CERTIFICATE OF APPROPRIATENESS

Property: 210 E 16th St, Tracts 1A & 2A, Block 139, Houston Heights Subdivision. The property includes a historic 1,880 square foot, one-and-a-half- story wood frame single-family residence and a detached garage situated on a 5,500 square foot (55' x 100') interior lot.

Proposal: Alteration – Remove a historic wood door and replace with a new wood and glass door. The applicant states safety concerns as the reason to replace the door and has provided a photo of a similar house that has been demolished as evidence to support the installation of a new door.

APPLICANT PHOTOS OF DOOR

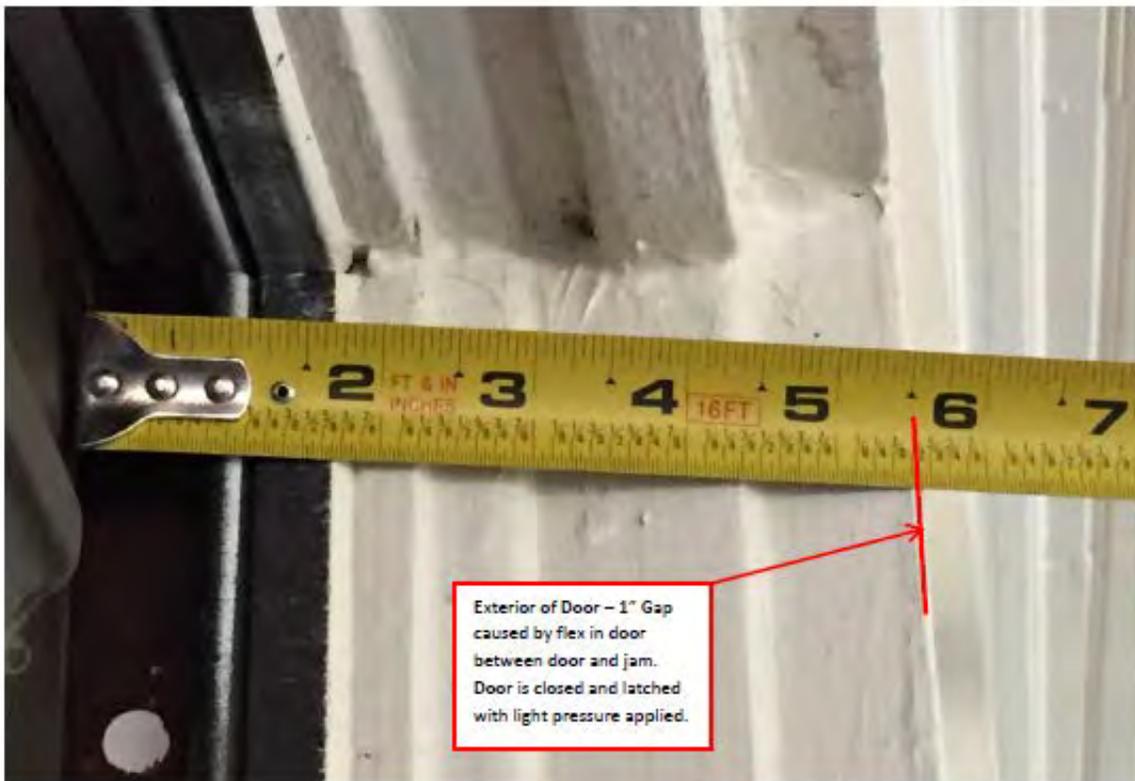
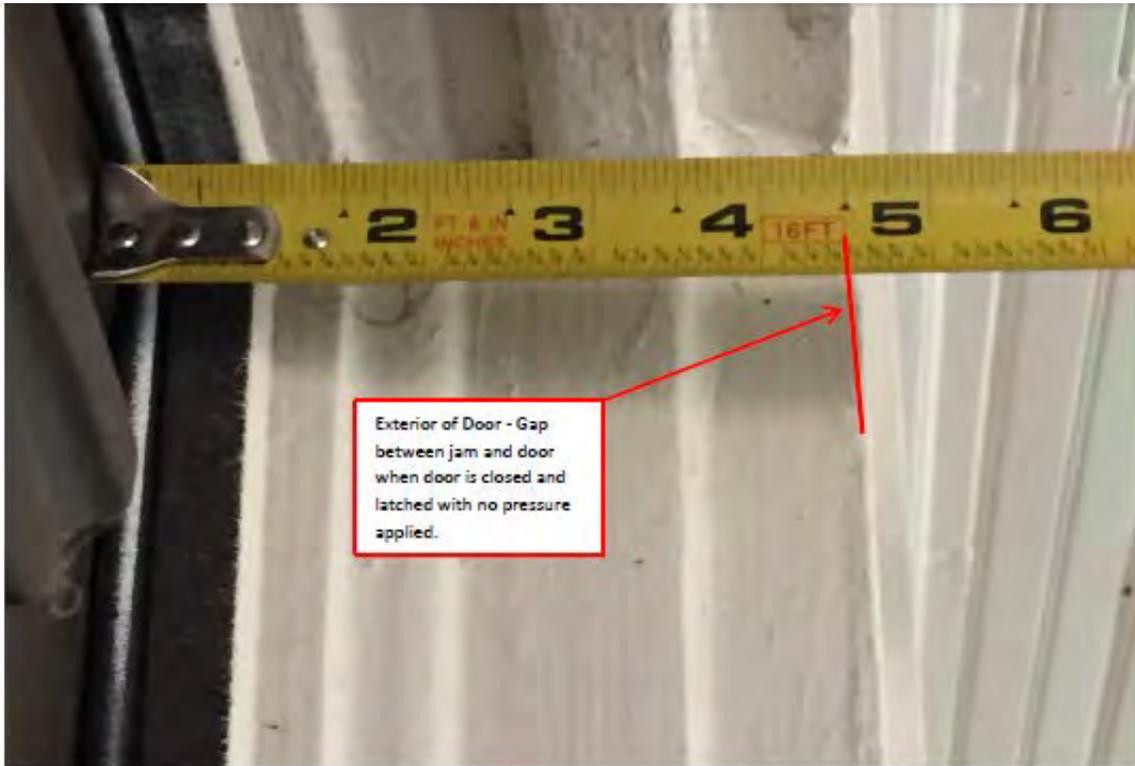
<i>The existing front door is a historical feature of the property and should be preserved. Though the house shown in the historic photo is similar, there is no evidence this structure had a door like the one in the photo.</i> |

HAHC Action: Approved with Conditions: Replace the door with a door similar to the front door in the historic photo to be reviewed and approved by staff; install new lattice around the foundation between the piers. Approved to replace the porch decking.

APPLICANT PHOTOS OF DOOR

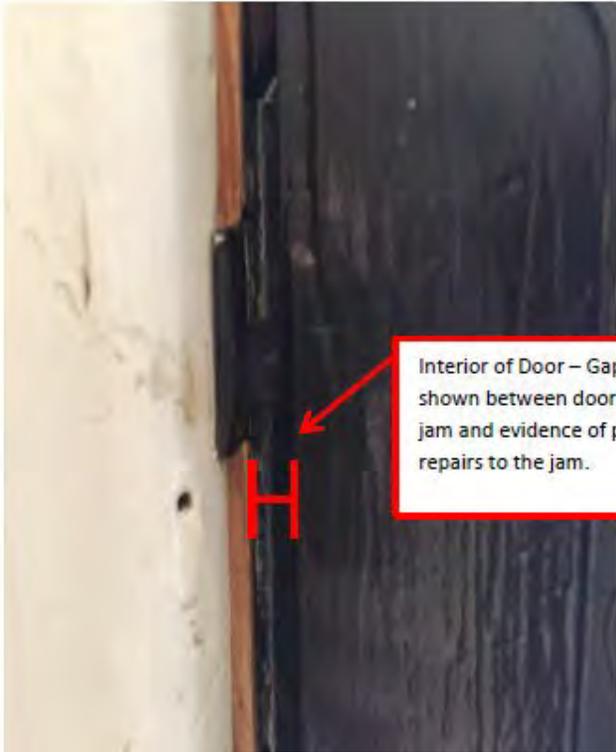
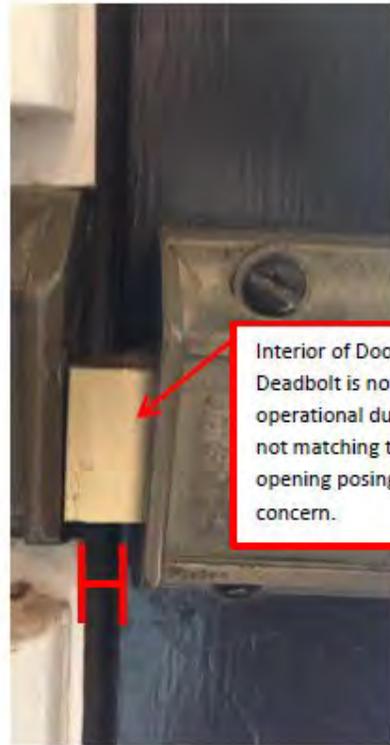
Interior of Door – Gap shown between door and jam and evidence of prior repairs to the jam.

Interior of Door - Deadbolt is not operational due to door not matching the original opening posing a safety concern.
